RE: Block F Rezoning/OCP Amendment Application Response to UEL Letter dated Feb 6, 2014

Re: Block F Development Approval Response from UEL dated February 6, 2014

To:	Steve Butt	From:	Steve Jeffares
Cc:	Gordon Easton	Date:	March 5, 2014
Project #:	Block F, 545-40	File:	12-125-03
Re:	Musqueam Block F – Development Approval Information

DATE: March 26, 2014
PROJECT: 4912-01
NO:
PROJECT: Block F Development, University Endowment Lands
SUBJECT: Response to UEL Staff Comments Regarding the Transportation Assessment Report

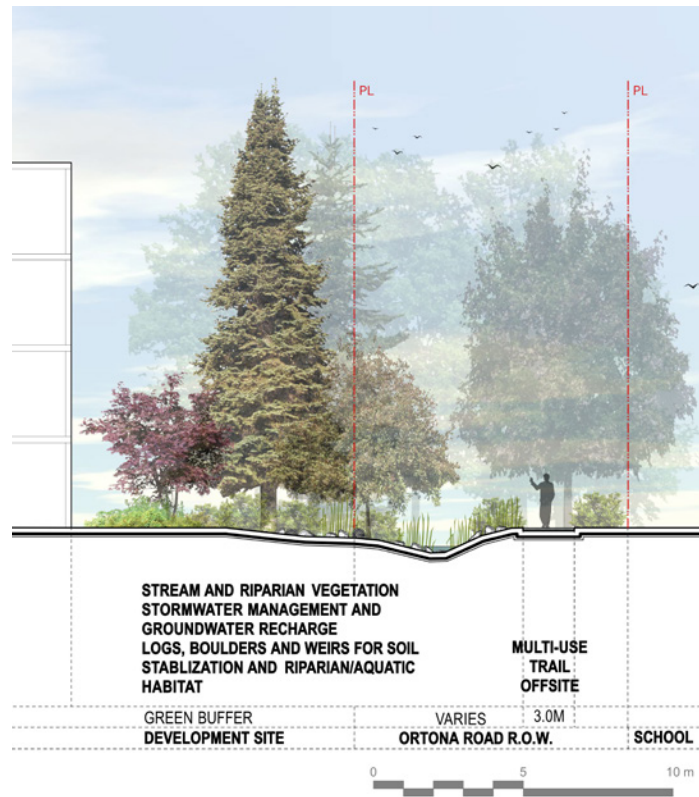
*d. **Active Space:** Please identify the location, area and type of active outdoor recreational space provided on Block F*

Response: Sheet 2 Active Outdoor Recreational Space indicates the proposed types and possible outdoor activities that the 5 main outdoor areas of Block F. We also indicate the off site activities on the adjacent school as the availability of this space as per the agreement with the school is an important factor in reviewing the proposed development.

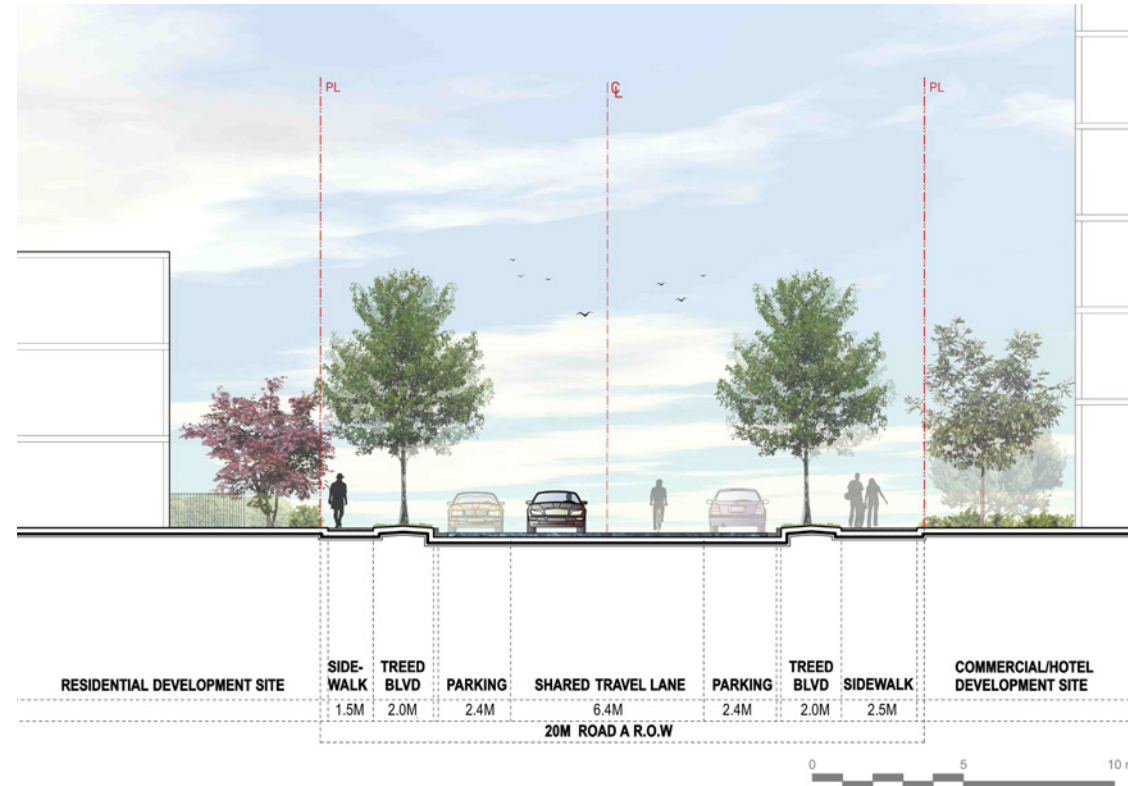
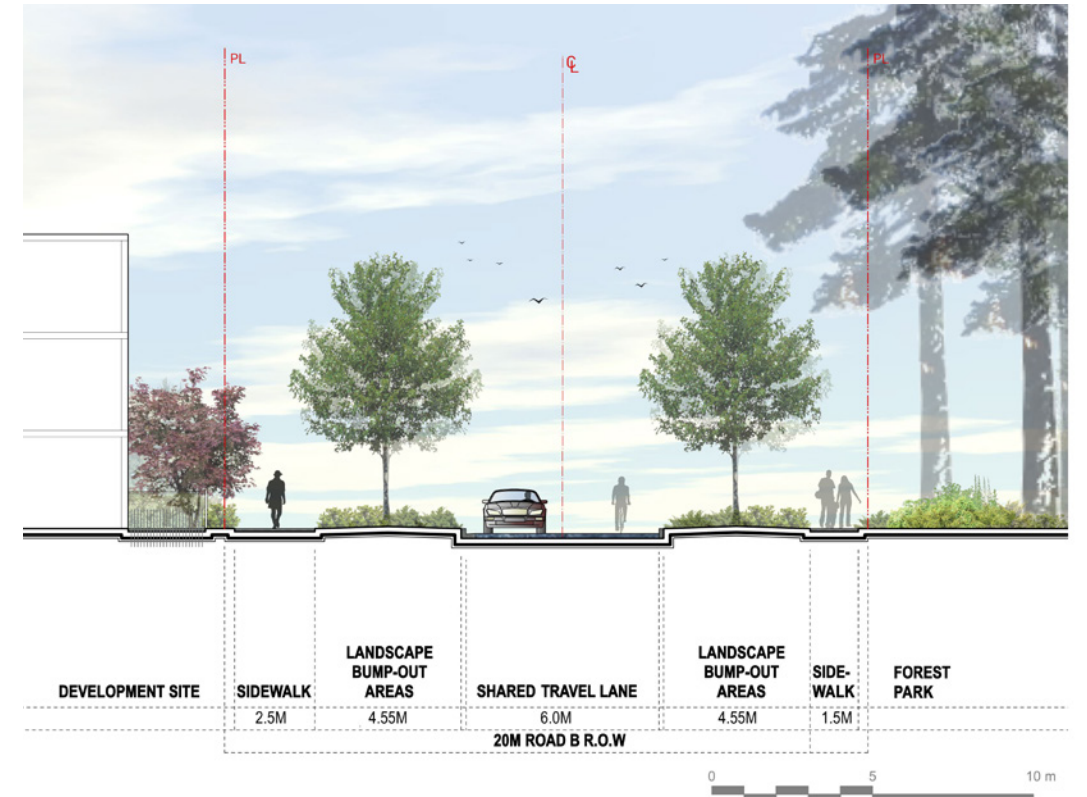
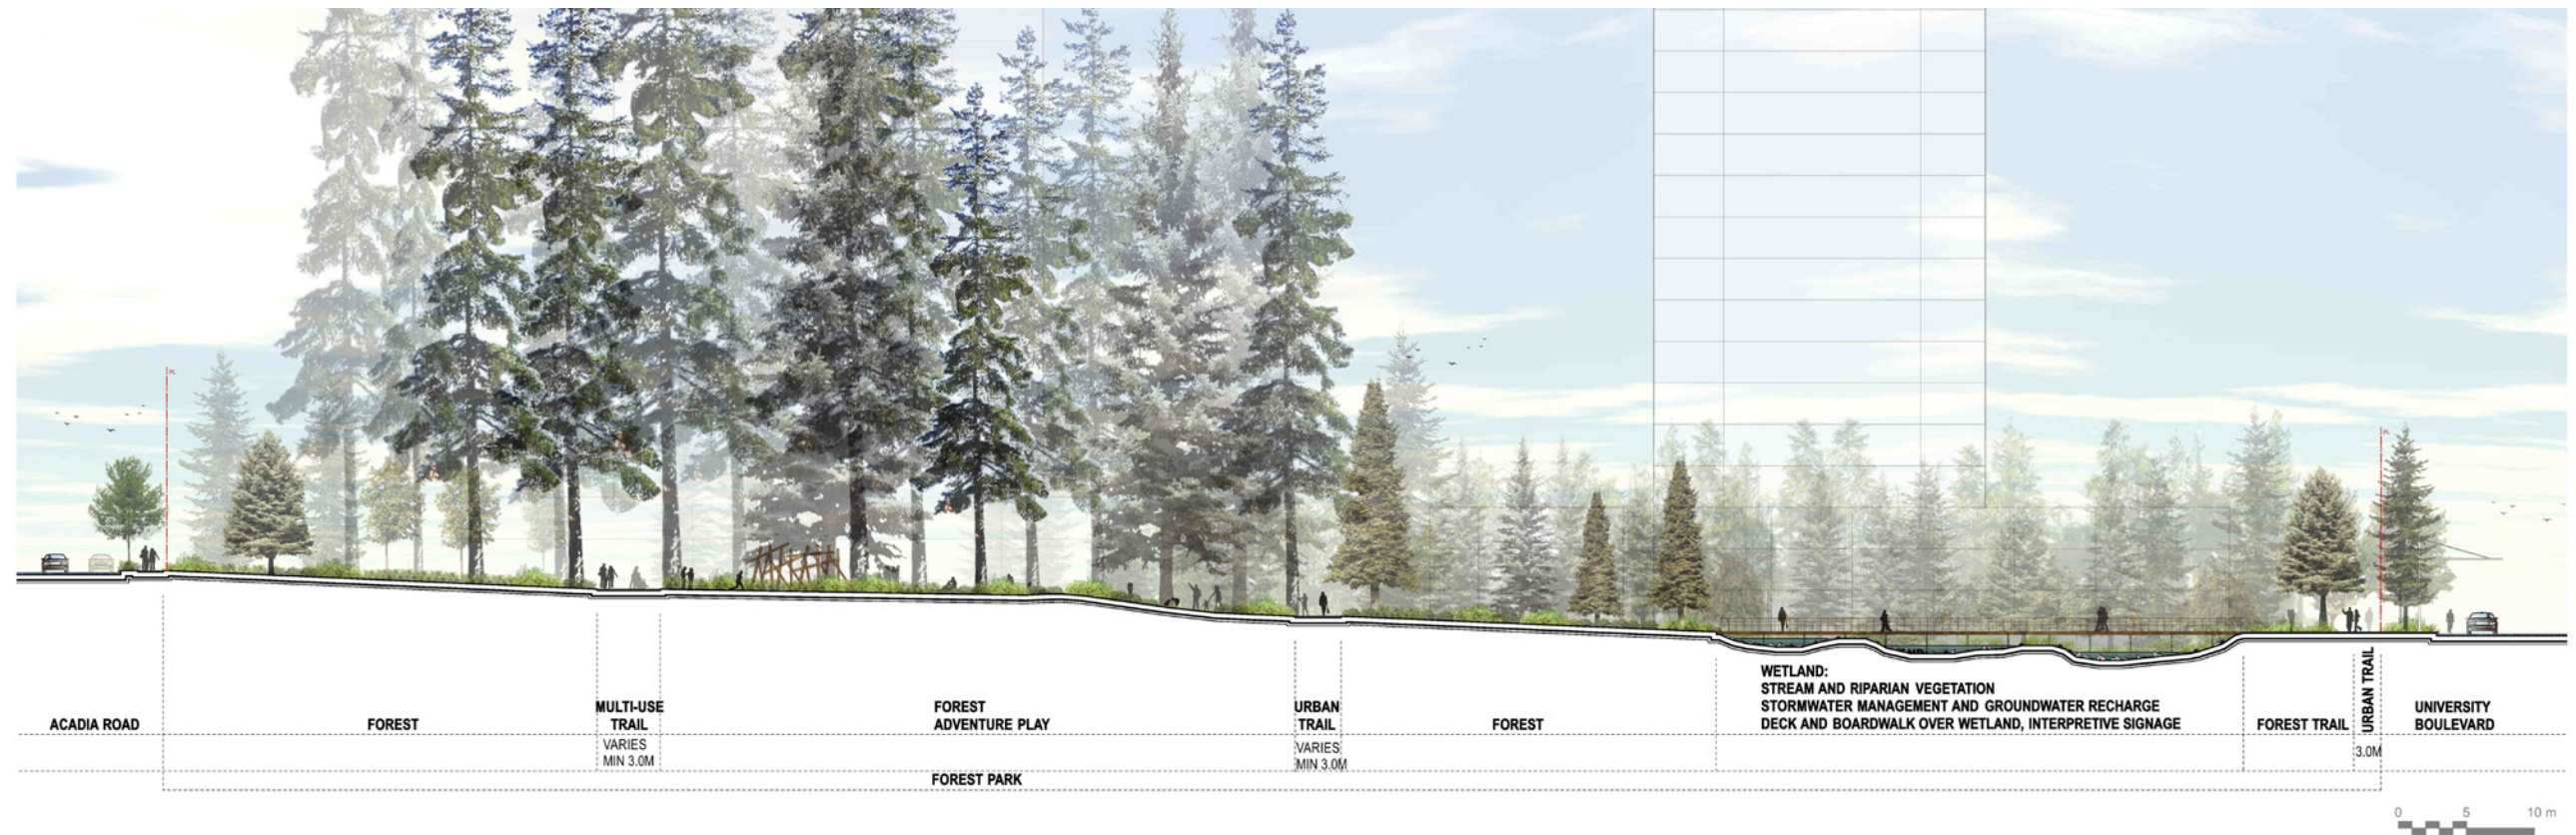
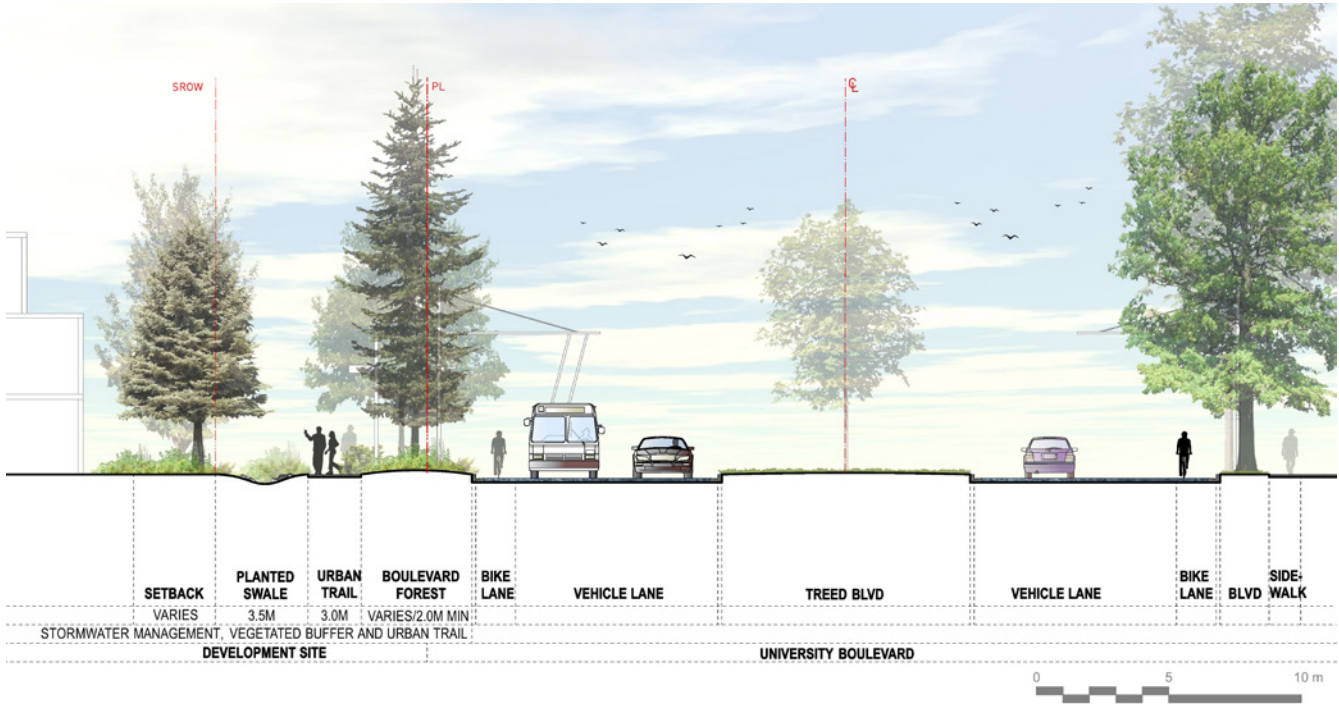
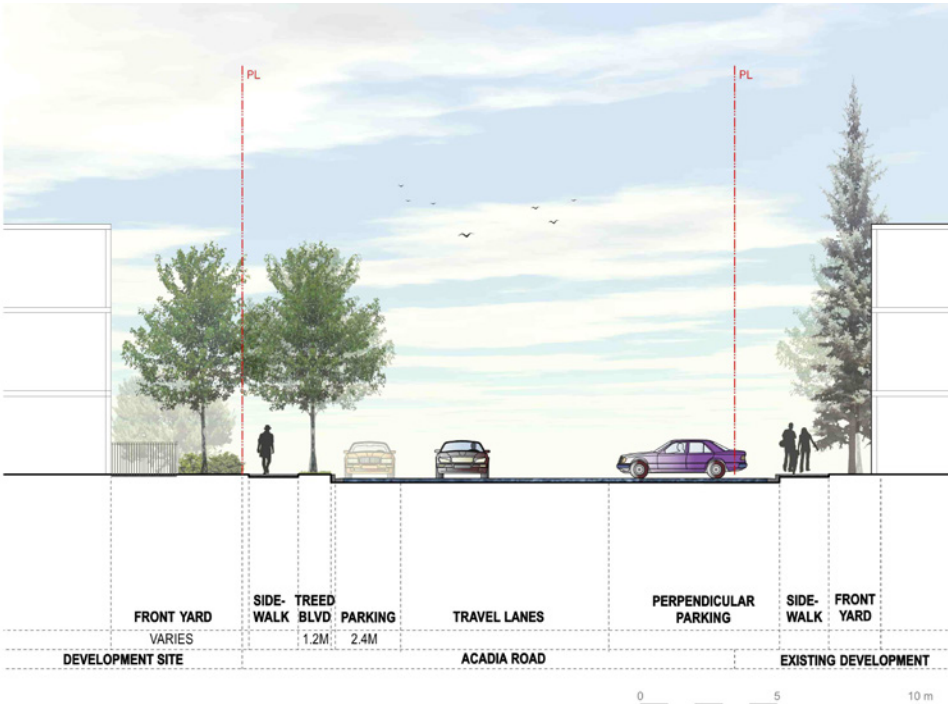
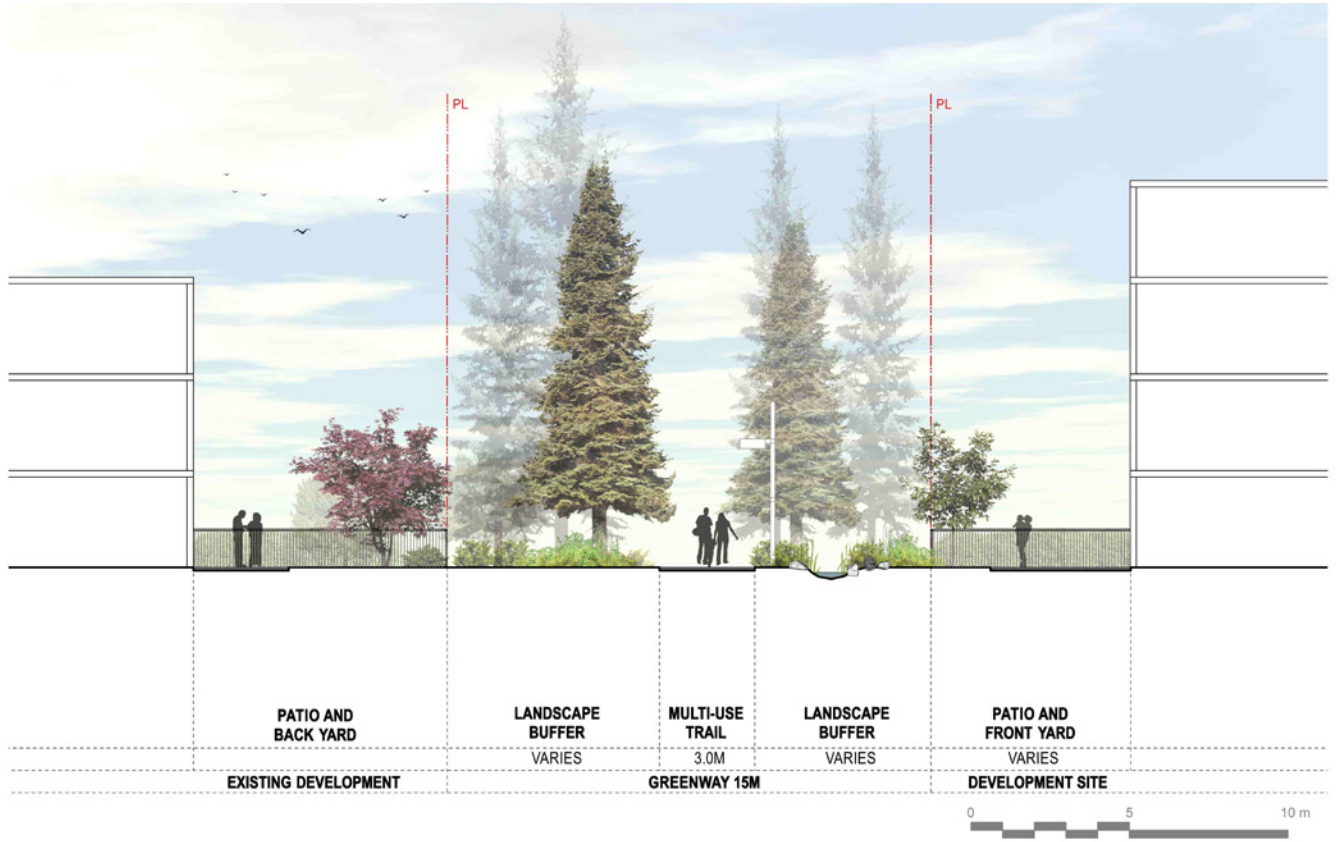
3f. Road Cross-sections: Please provide detailed cross-sections with complete measurements for both University Blvd. and Acadia Rd. To demonstrate that there is sufficient width for what is proposed. Please show the "worst case scenario" (e.g. where there is the least amount of available setback). Please provide a larger, to-scale version of Figure 2.17 that shows conceptually sufficient measurements to assess the feasibility of this plan.

With regards to the road cross sections, our plans are primarily intended for character illustration, and as such only a few key locations are included. We have coordinated with Binnie Engineering to ensure the standard road cross sections are correct. We have corrected a few inconsistencies we noticed in the dimensions of our sections.

The Landscape Plan has been updated. Also, for detailed measurements, please refer to the updated Civil Plan. Based on the Landscape and Civil plans, it is confirmed that there is sufficient width to accommodate the proposed cross-sections.
